**Final report on the
Impact Assessment accompanying the
Strategy for Reducing Heavy-Duty Vehicles Fuel
Consumption and CO₂ Emissions – SWD (2014) 160 final**

18th January 2016

IAI-HDCO₂-160118f

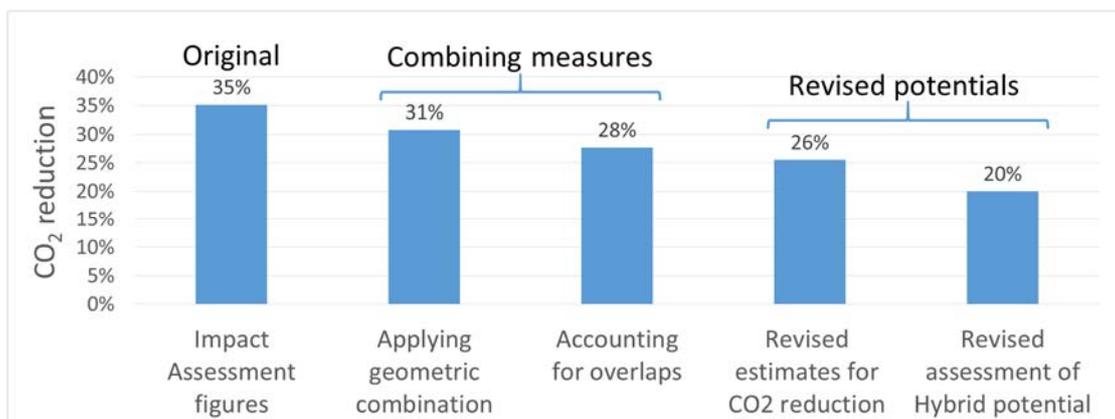
- Use of the mathematically correct geometric combination of potentials (-4.3%)
- Accounting for overlap of the effect of technologies (-3.1%)
- A revision of the CO₂ reduction potential of certain technologies (-2.2%)
- Considering the potential without hybrid technology, due to the use of a 90% subsidised cost figure for one vehicle application casting uncertainty on all figures (-5.5%)

The chart below shows the recalculated cost effective weighted average CO₂ reduction potential, introducing cumulatively the effects and scenarios investigated by the IAI resulting in a quantifiable difference:

Figure 1: Chart from TNO 2006 report showing technology combination calculation methodology

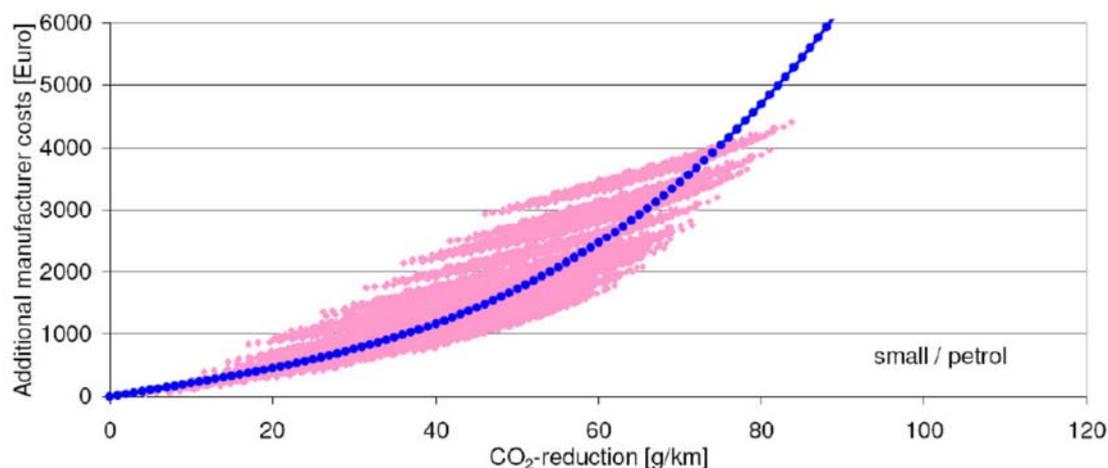
Using an alternative simpler method, this potential overlap was considered by TNO et. al. in their 2006 report underlying the European Commission Impact Assessment for CO₂ passenger cars (Contract nr. SI2.408212, pp55-58). Cost curves were plotted with all possible technology combinations and a trend line added with 2/3 of the points to the left of the curve (lower CO₂ reduction) and 1/3 to the right, see example below.

Analysing the cost curves in the 2006 report, the “discount” created on the CO₂ reduction potential using the above method varied between 7% and 15% depending on vehicle size and fuel type.

Figure 2: Chart of cost effective CO₂ reductions for all vehicle types under different assumptions

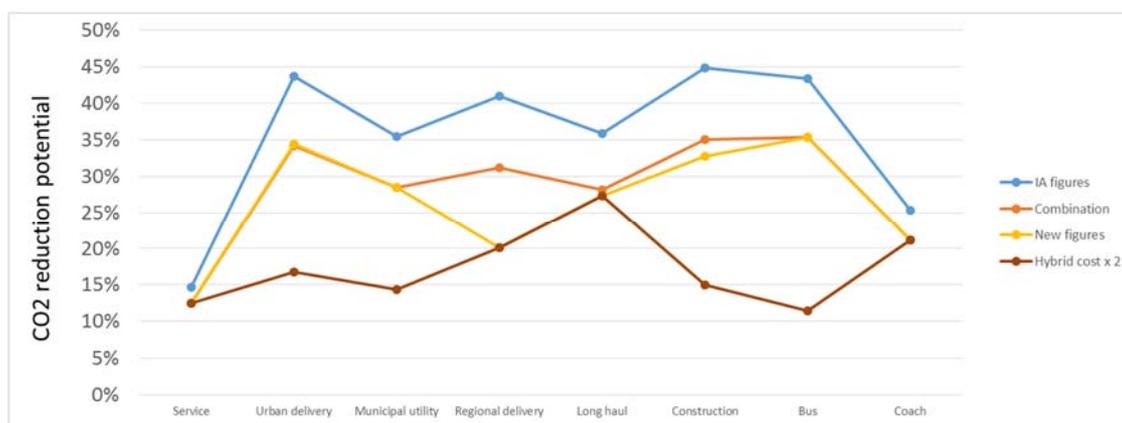
A simple sensitivity analysis assuming a doubling of the quoted cost of the technology has been performed, with the resulting effect on the aggregate cost effective CO₂ potential clearly shown in Table 9 and Figure 2 (Section 3.3 below).

These results are also shown graphically below (figures for 7% discount rate, €30/t cost effective cut-off and subtracting behavioural measures are not included since the effects are not large, in order to make the chart readable):

Annex V: Scatter plots for methodology accounting for technology overlap

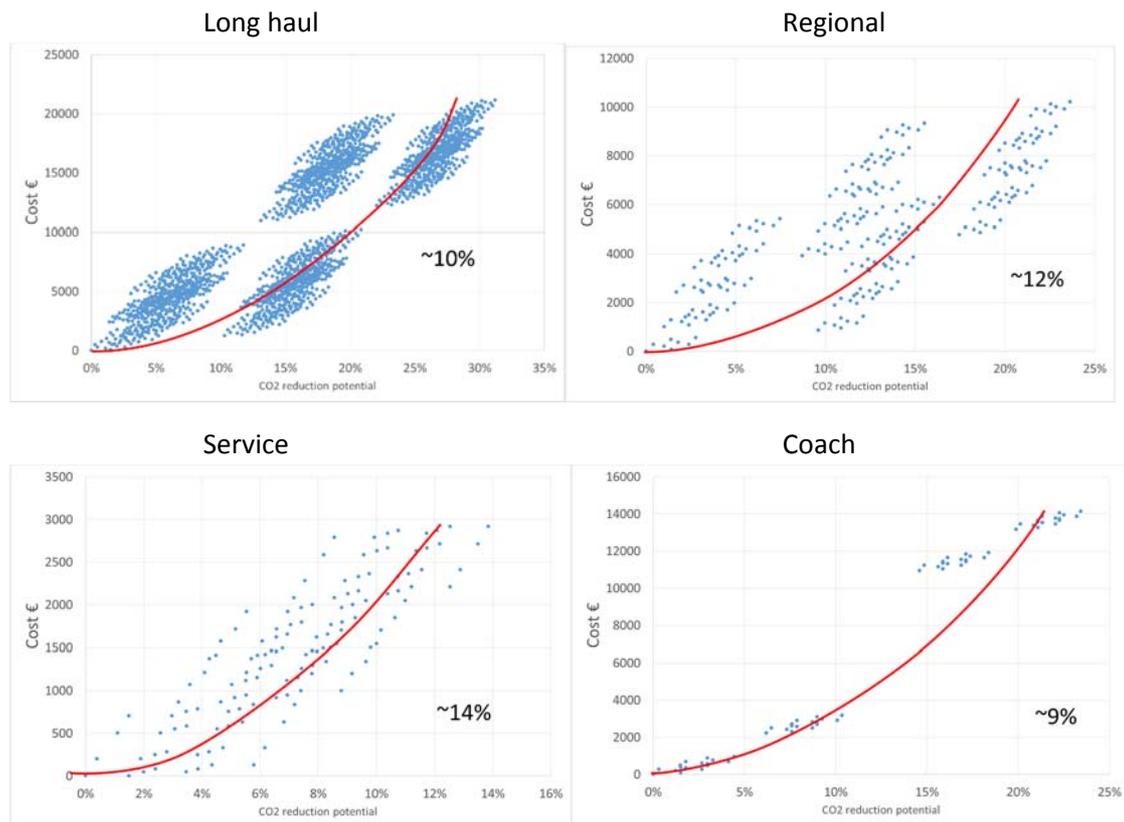
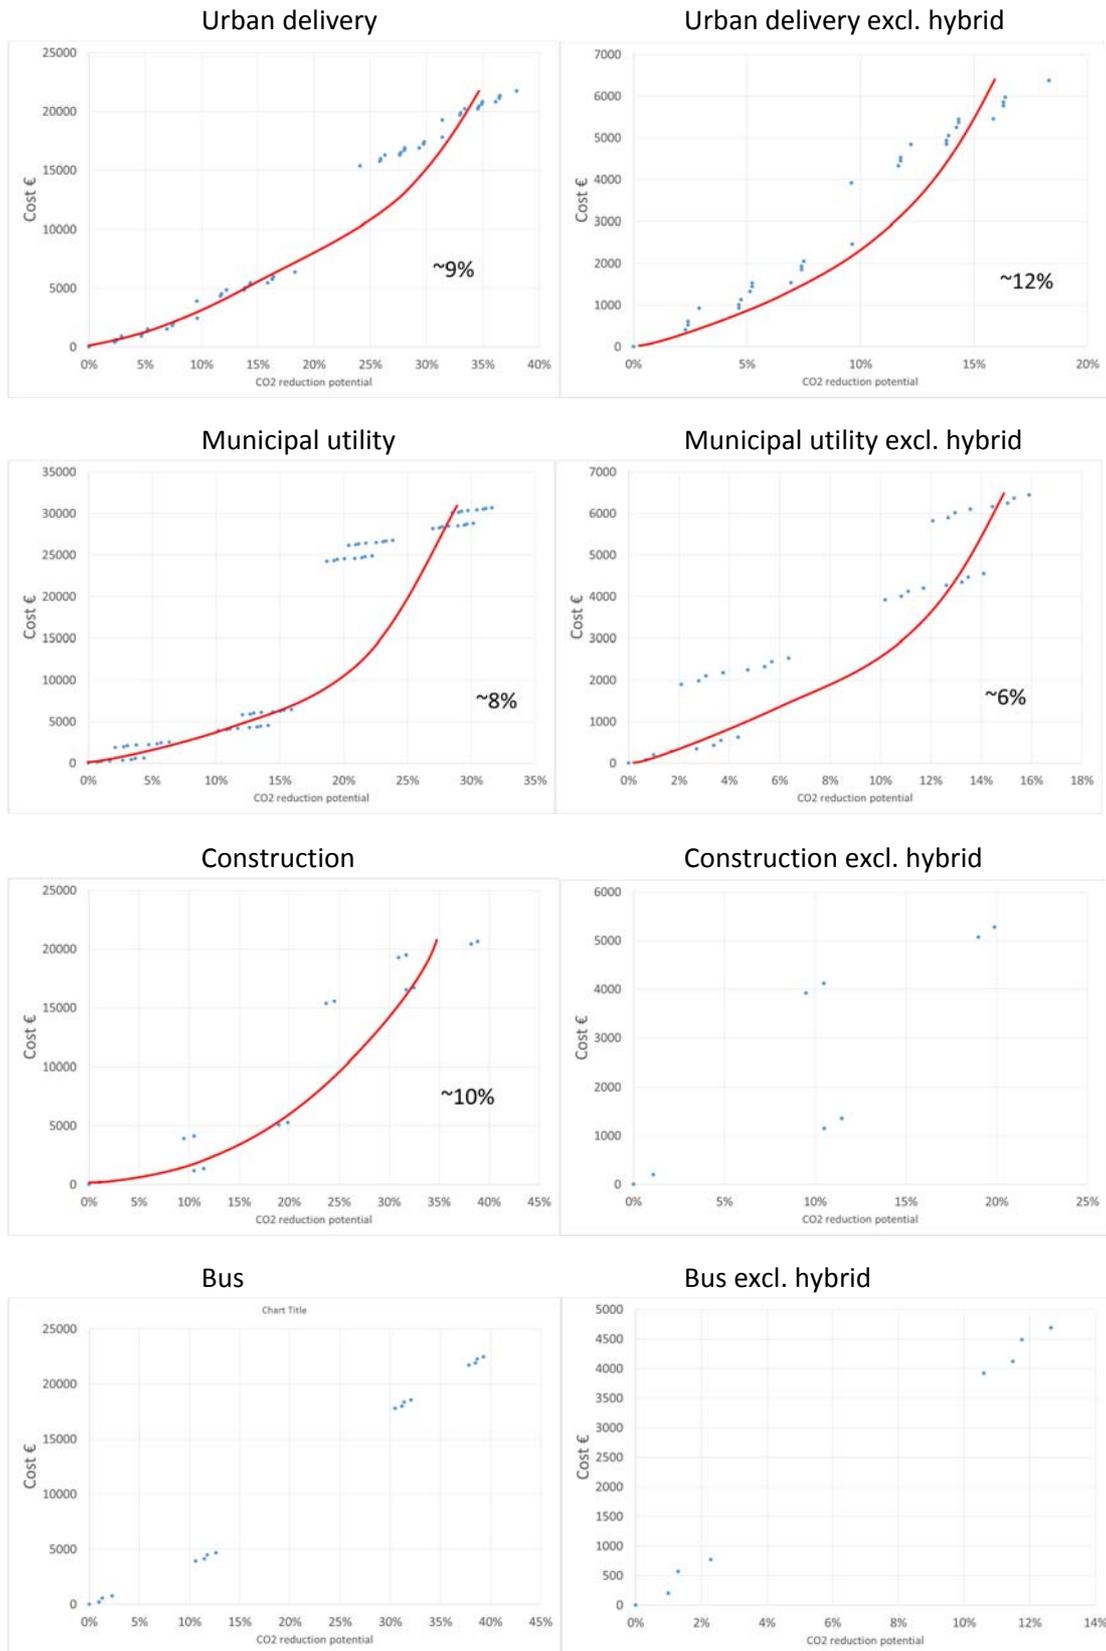
Scatter plots have been created for each vehicle type showing all combinations of CO₂ reduction potential and cost of measures. Due to the inhomogeneity of the scatter plots, no mathematical function could be found to create a trend line through the points to reflect the TNO 2006 methodology. Instead, a trend line has been inserted using a visual estimate to create a rough value for each technology.

Only those measures determined as cost effective by the Impact Assessment have been included in the scatter plots. To reflect the analysis in this report (section 3.2.1), an additional plot has been created excluding the hybrid technology in cases where the Impact Assessment found this technology to be cost-effective.

Lacking a more robust methodology, the 10% discount factor is therefore selected for all vehicle types.
